**REPORT TO  
PLANNING AND DESIGN COMMISSION  
City of Sacramento**

**REVIEW & COMMENT  
June 2, 2016**

**Subject: Land Park Commercial Center (P15-048) - Review & Comment**

SITE PLAN

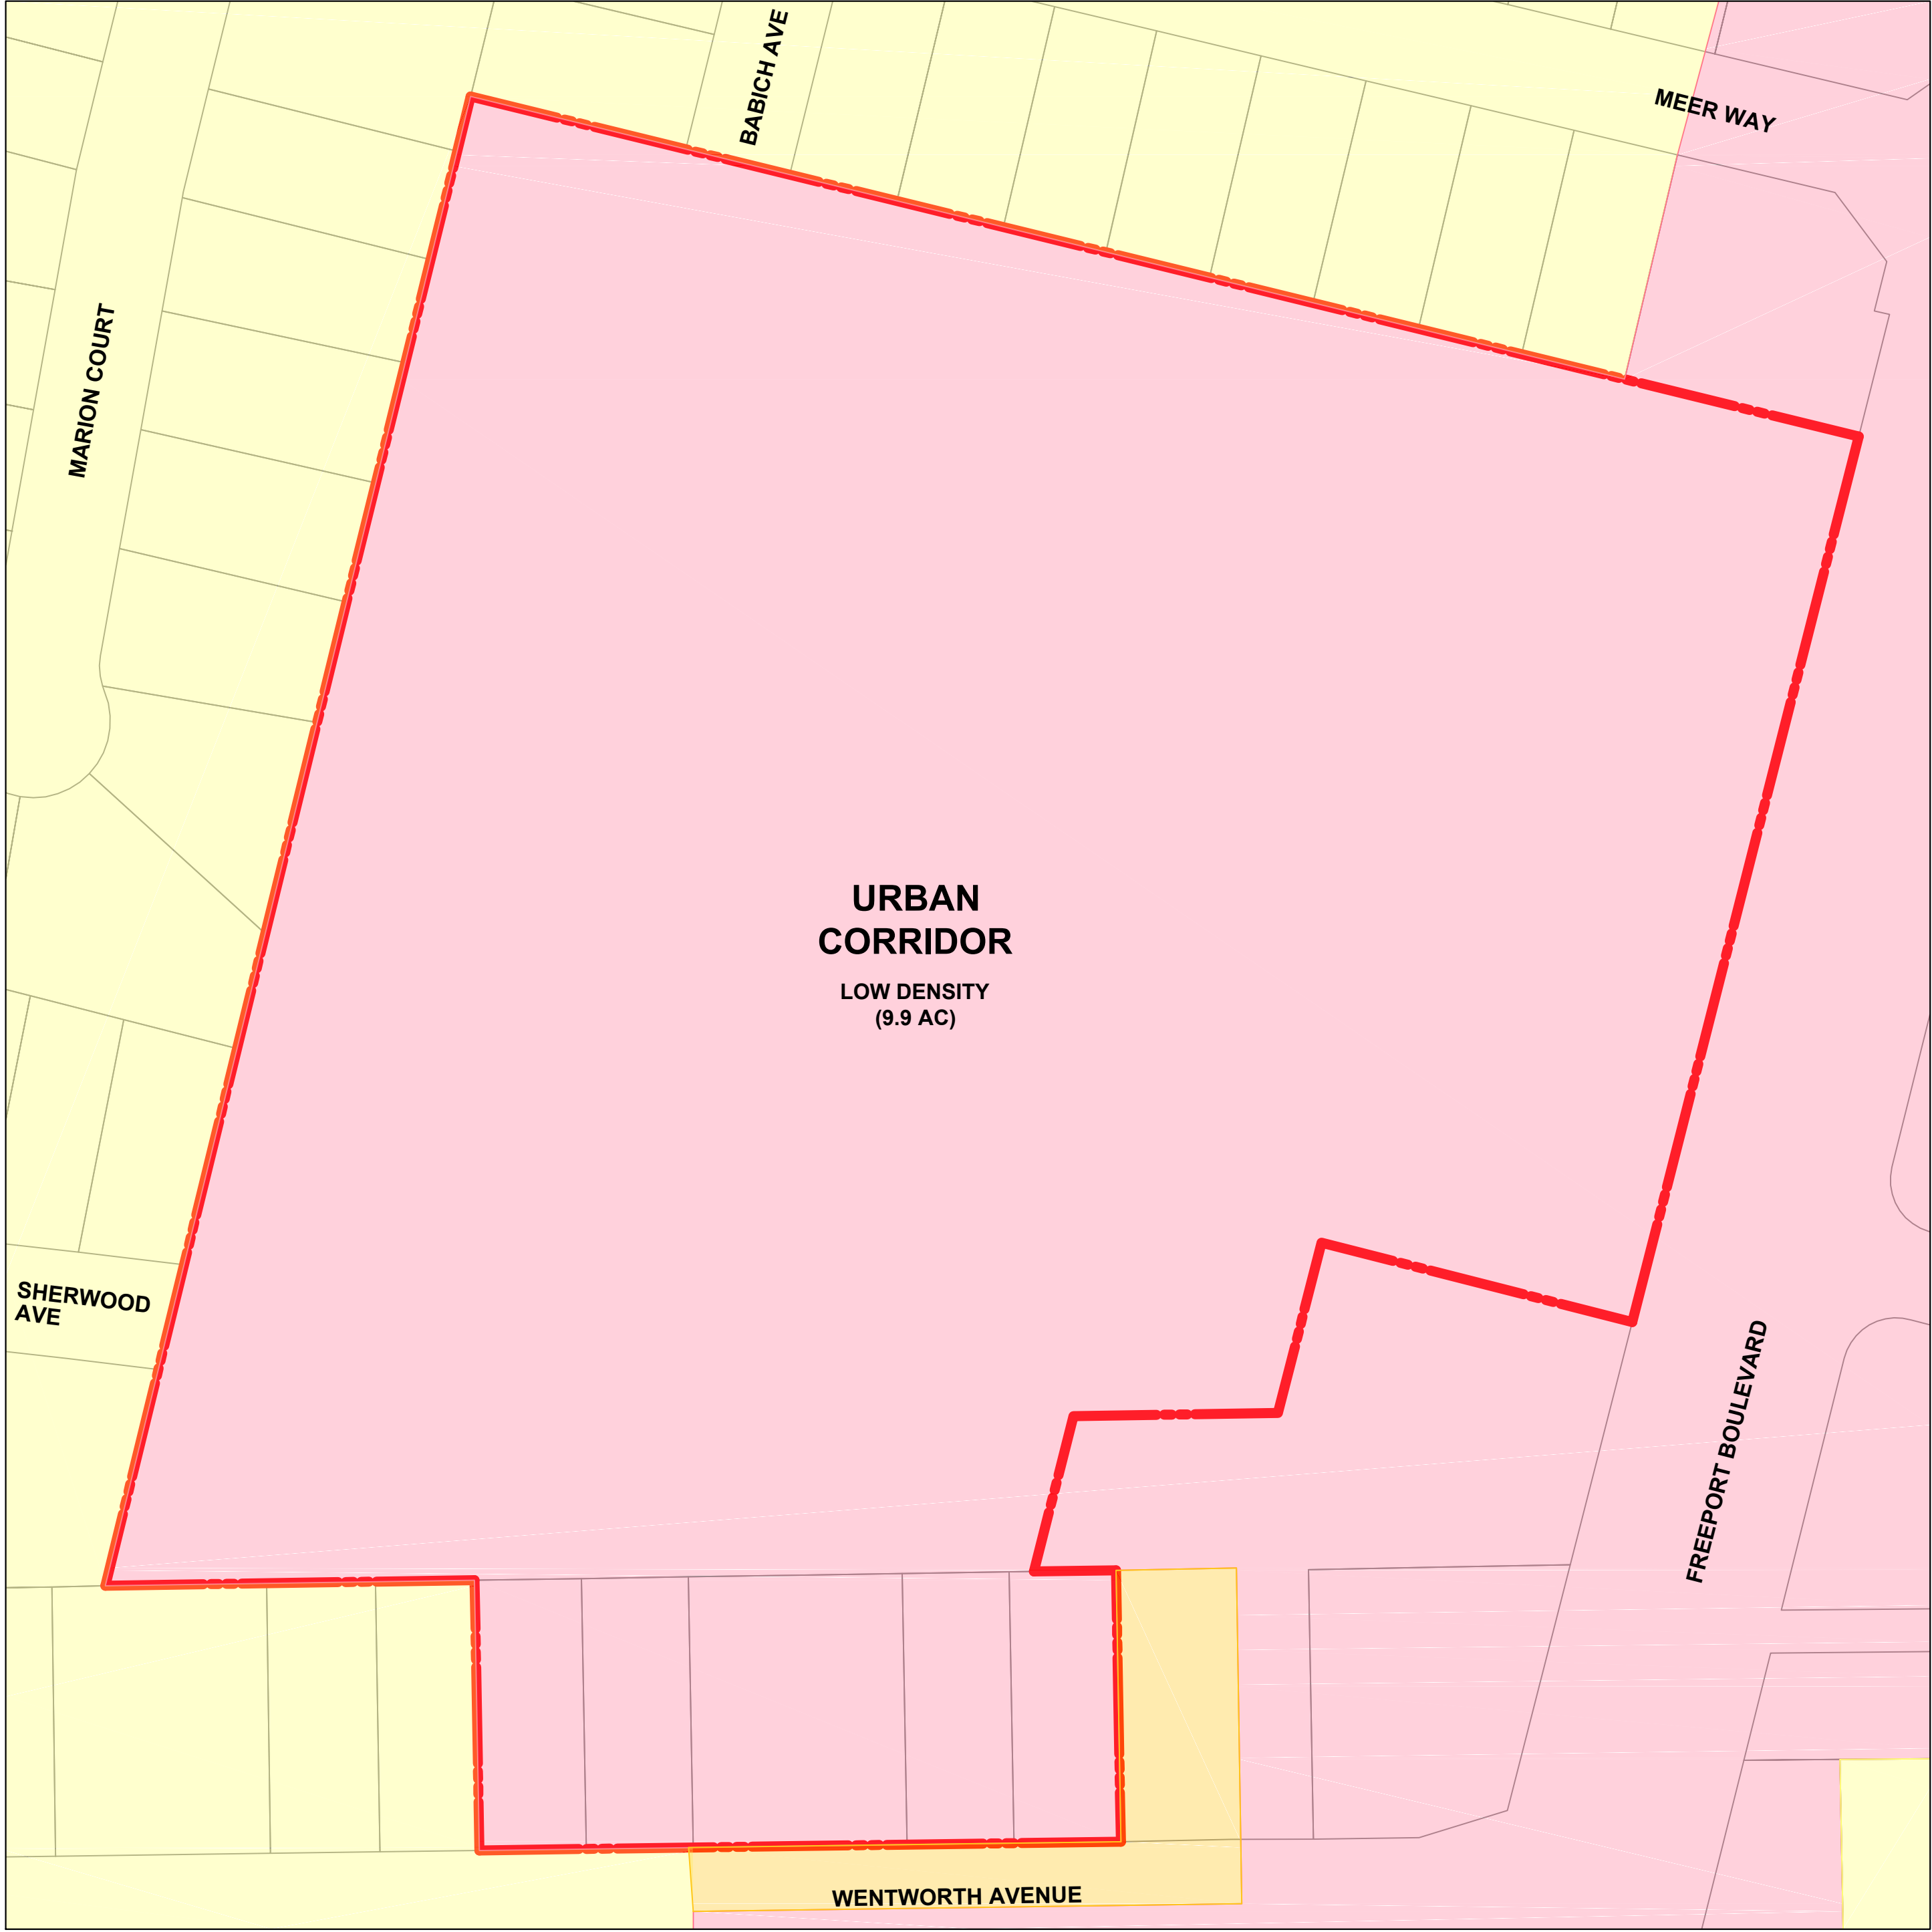
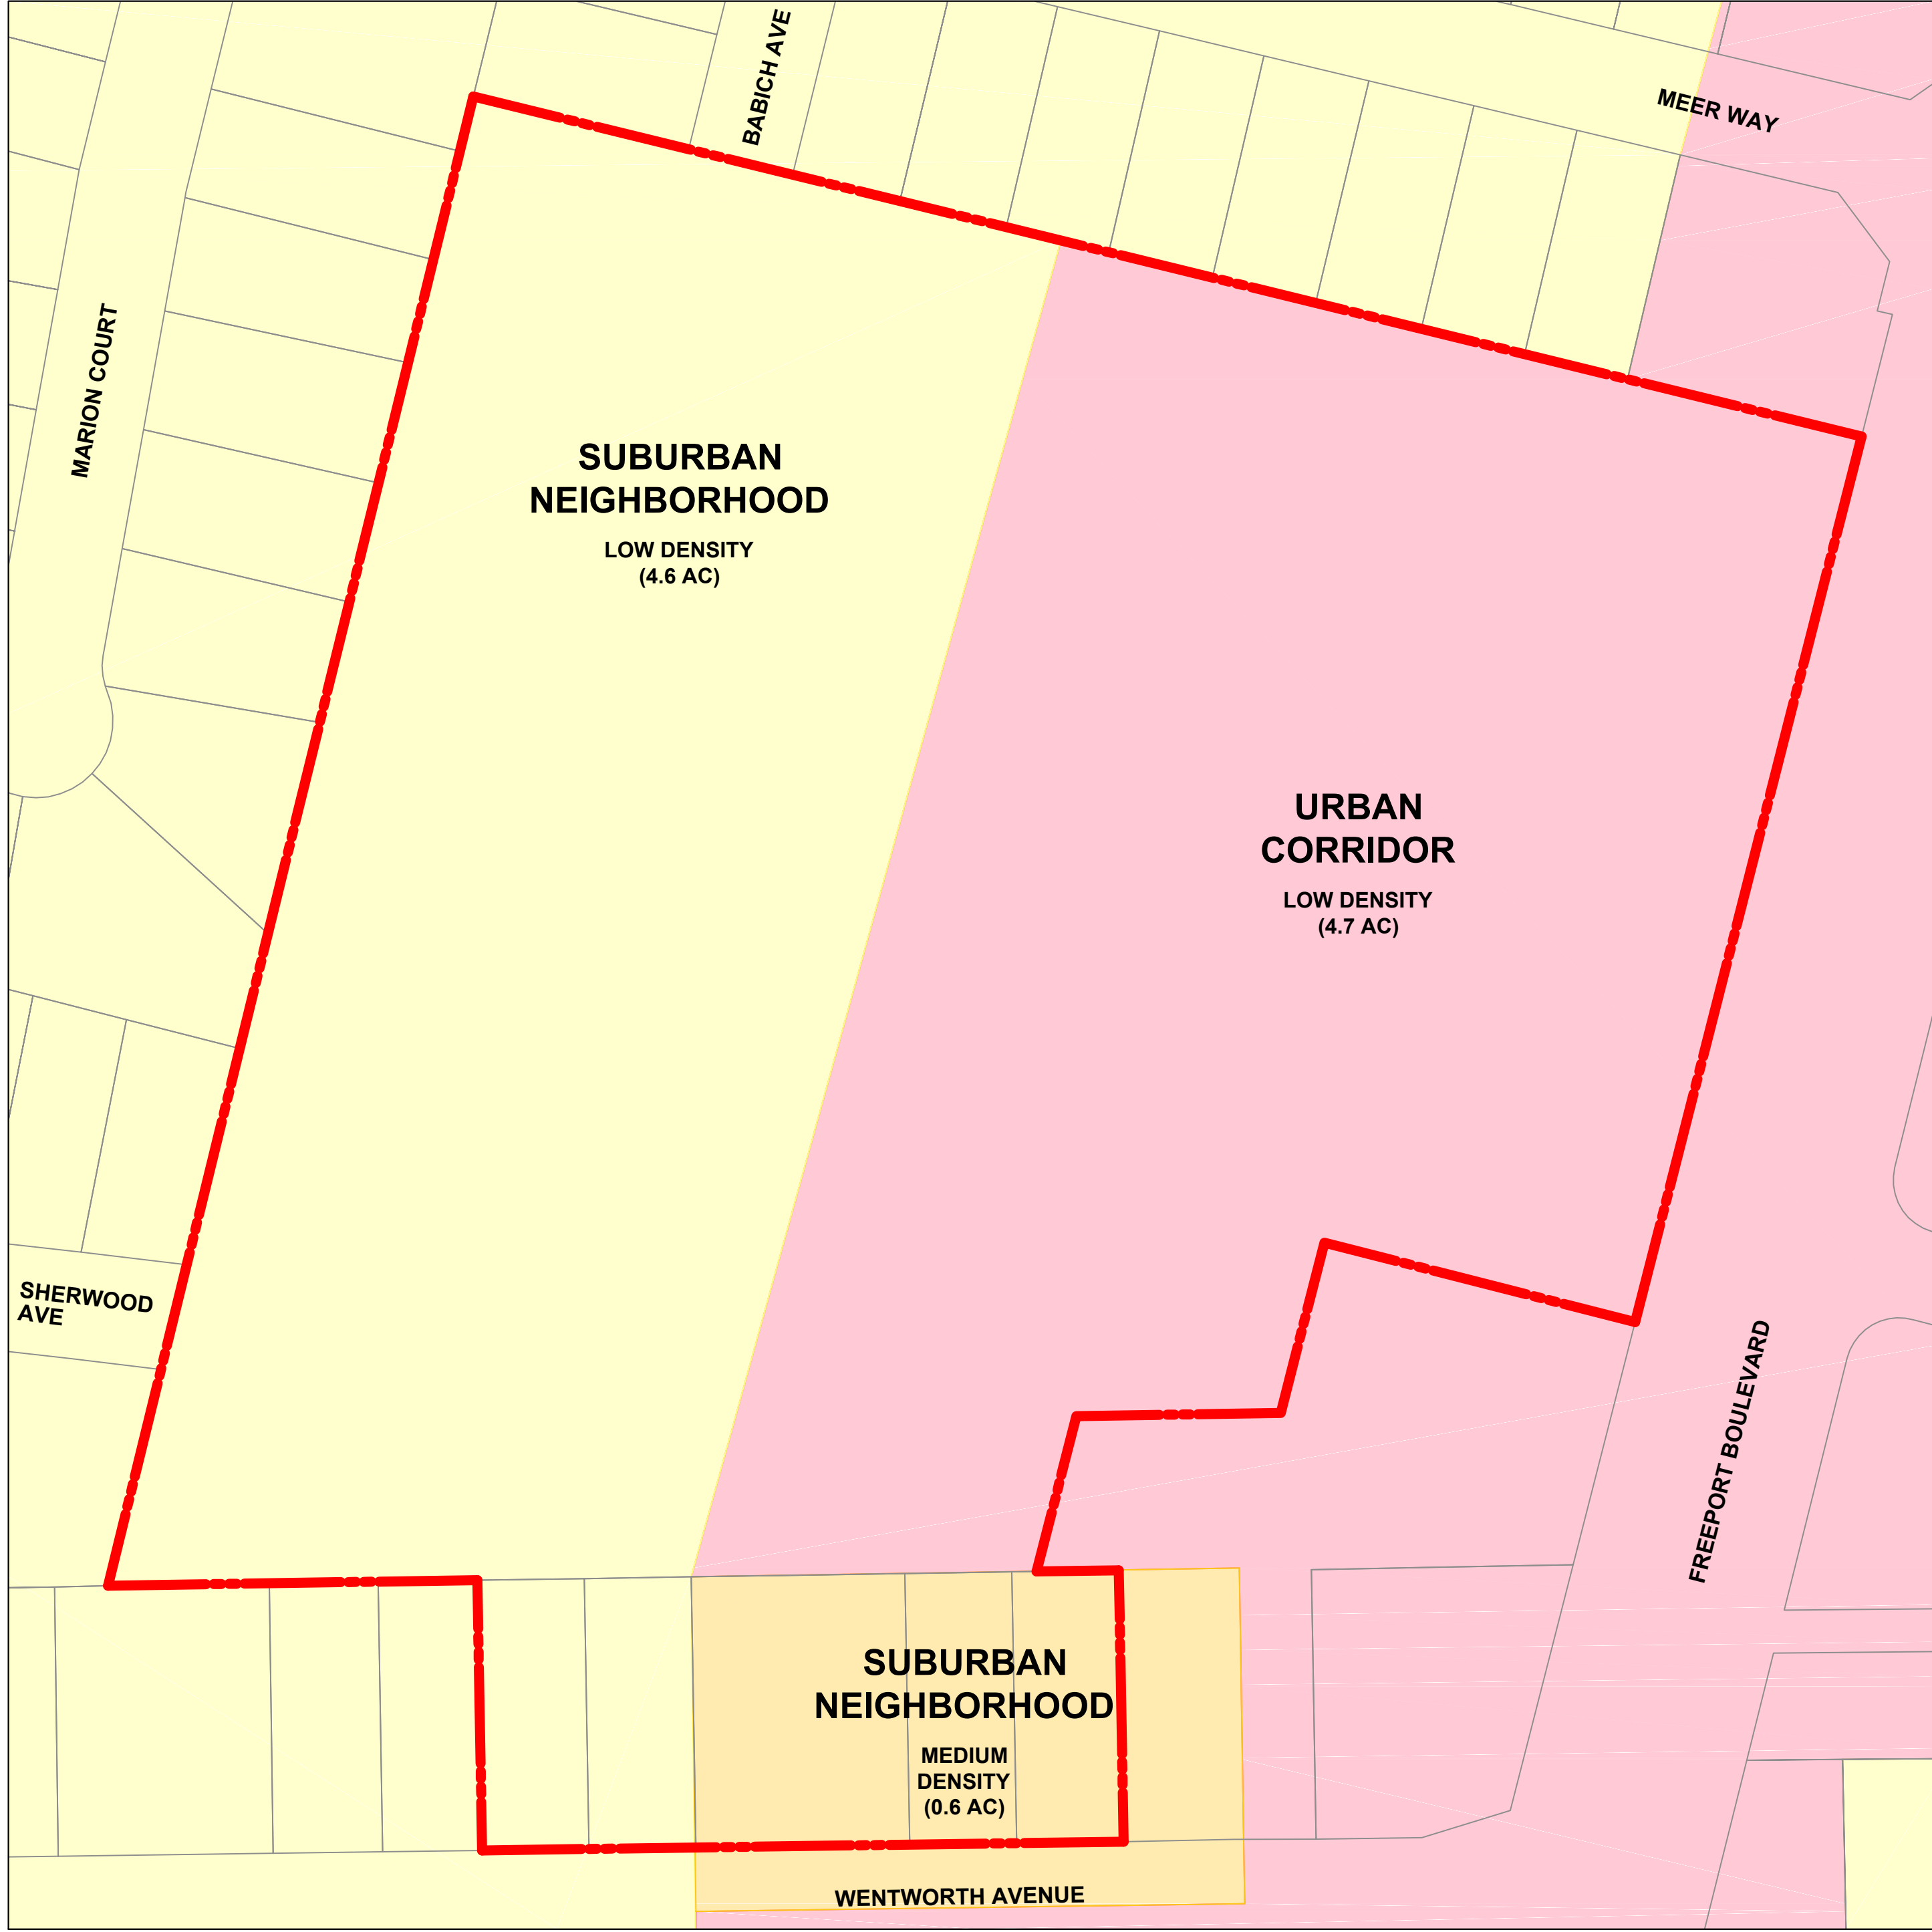
We also request that the project provide lanes for bicyclists into the project site that are separated from the vehicle lanes. The current site plan shows single vehicle lanes with bicyclists forced to share those lanes. Shared lanes will be problematic for many riders especially during heavy shopping periods.

Bicycle Access on the Project Site. The proposed site plan shows that bicycle access on the site would be shared with vehicles in a typical shopping center parking lot configuration. We believe that this type of bicycle access will not be inviting to the many people of all ages and abilities who could bicycle from surrounding neighborhoods if they felt comfortable. In fact, many people, for example many seniors, women, and children, although interested in bicycling, are not comfortable sharing vehicle lanes with cars and trucks. Especially at the immediate entrances to the site from Freeport Boulevard and Wentworth Avenue, traffic of cars and delivery trucks may be heavy at times.

The proposed site plan shows access routes for pedestrians from the proposed site entrances. We request that the project provide comparable access routes for bicycles from the entrances to primary areas for bike parking (for example, at the grocery store entrance, at the plaza in front of the "Shops 2" building, and at the "Paseo" between the "Shops 1A" and "Shops 1B" buildings). These bike access routes should be separated from vehicle lanes where they enter the site, at least 8 ft wide, and demarcated with pavement-surface treatments to distinguish them from pedestrian routes. Wayfinding signs should be provided to direct bicyclists to bike-parking locations.

4. Where will Raley's employees and the other proposed tenants park? The homeowners of Meer Way will probably have to get permit parking in order to park in front of our homes.
5. The plan shows a dumpster behind our back yard fence. This should be relocated to avoid smell from dumpster and the noise caused by emptying the dumpster.
6. We are concerned of increased pollution from the 439 parking stalls for the proposed site - Again, affecting our use and enjoyment of our backyard.
7. Access to proposed Raley's site. Going North on Freeport Blvd., you can only enter the Capitol Nursery/proposed Raley project by making a U-turn at Freeport Blvd. and Meer Way. Unless the median on Freeport Blvd. is eliminated, traffic at Meer Way & Freeport Blvd. intersection will be problematic for the residents on Meer Way and the traffic flowing South on Freeport Blvd.

1. The developer should add walls on the property line adjacent to existing homes. The plans show that there will be a wall, but the height listed is inconsistent. One page says 10' and the other says 12'.
